Item #7  
MCPB  
11/13/03

**DATE:** November 7, 2003  
**TO:** Montgomery County Planning Board  
**VIA:** Joe R. Davis, Chief  
Michael Ma, Supervisor *MM*  
Development Review Division  
**FROM:** Wynn E. Withhans, RLA, AICP *WW*  
Planning Department Staff  
(301) 495-4584  
**REVIEW TYPE:** Site Plan Review  
**APPLYING FOR:** Approval of 195 multifamily units inclusive of 64 MPDU's and 53 TDR's on 10.44 acres  
**PROJECT NAME:** Kings View Village - Phase I and II  
**CASE #:** 8-97007A and 8-94031C  
**REVIEW BASIS:** Div. 59-D-3, Montgomery County Zoning Ordinance for Site Plan  
**ZONE:** R-200/TDR -6  
**LOCATION:** Southwest quadrant of MD Route 118 and Leman Farm Road  
**MASTER PLAN:** Germantown  
**APPLICANT:** Pleasants Investment Partnership  
**FILING DATE:** April 17, 2003  
**HEARING DATE:** November 13, 2003

# KINGSVIEW VILLAGE - SEC. 8 (8-97007A)

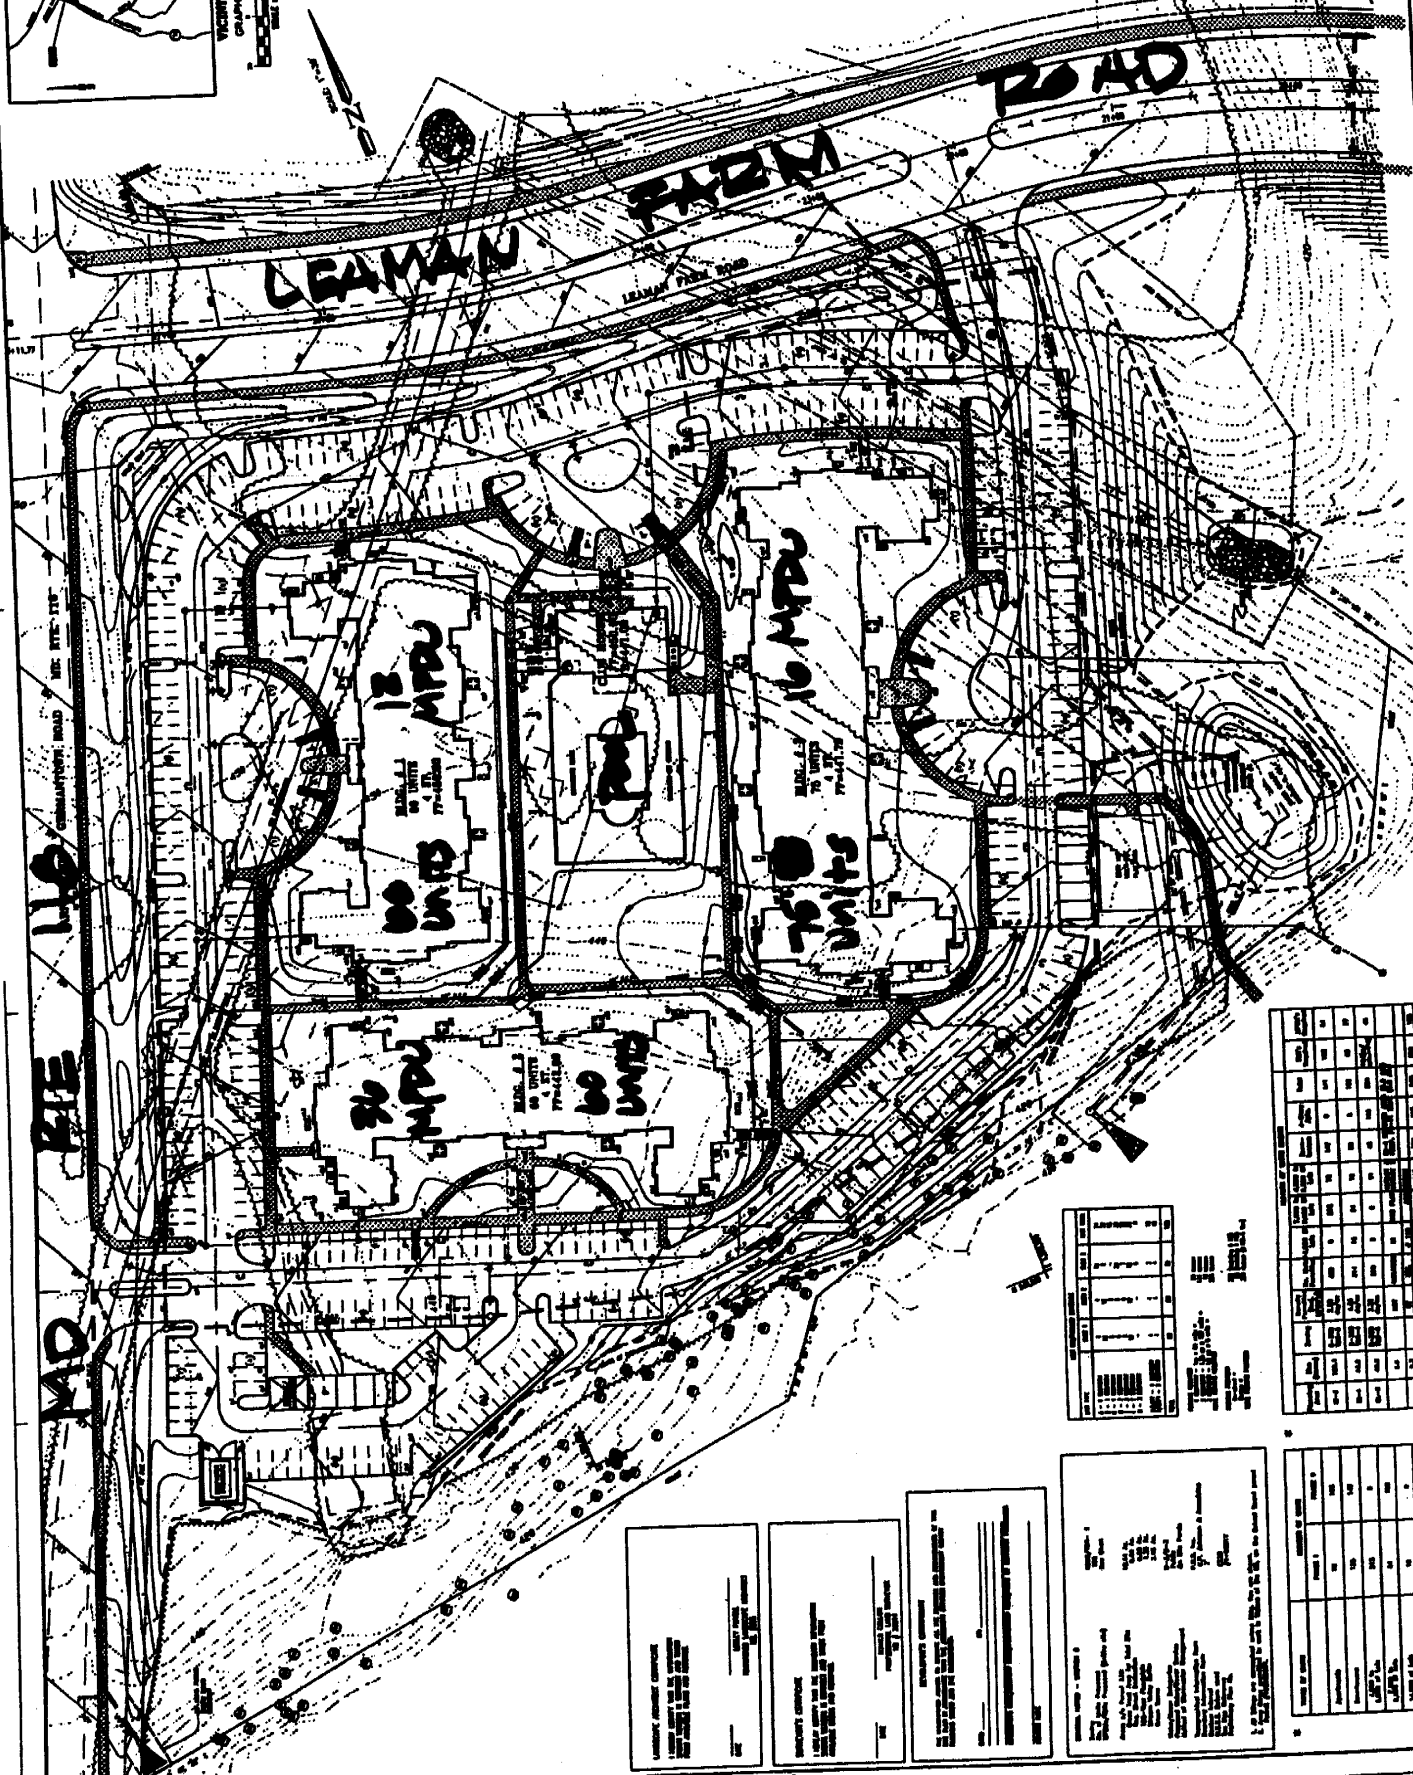
A pedestrian system connects the building entrances to the open spaces and the parking lot. Pedestrian connections are made to the adjacent public streets through the parking lot. The plan proposes sidewalks along MD route 118 and Leaman Farm Road's northern edge. The MD Route 118 sidewalk should be relocated to be at least 8 feet away from the curb for greater pedestrian safety. This same walk needs to be connected to other walks along the southern edge of MD Route 118 and is recommended with this approval.

Landscaping includes street trees along the site frontages, shade trees within the parking lot and extensive beds of ornamental planting that provide screening for the parking lots and between walks and buildings. The central open space is highlighted by the pool and pool house. Lighting is provided on the site as well. More detail is needed to analyze the lighting condition along the property line and the light fixtures need to be adapted to provide cut-off features.

1. Lighting and Landscaping Plan
  - a. Revise sidewalk location along MD Route 118 - construct new walk a minimum of 8 feet from the curb, adjust street trees accordingly.

- b. Plant street trees on both edges of Leaman Farm Road and in the median, respecting eventual curb locations.
- c. Additional evergreen screen planting to be included along the western edge of the parking lot (by the 12 spaces) adjacent to MD Route 118.
- d. Include sitting areas on landscape plan, add 2 benches to front of pool house entrance.
- e. Lighting - The light fixtures to include reflectors that reduce the upward light throw and convert the fixture in to a full cut-off or semi- cut-off light throw pattern per IESNA guidelines. The light fixtures selected may be retrofitted to show the same. The photometric point to point study needs to extend to the property lines show the light levels are .01 along all property lines.
- f. Bike and motorcycle parking to be provided on site per 59-E.

- a. Additional sidewalk connections from the parking lot to the circular walks shall be added per staff sketch.
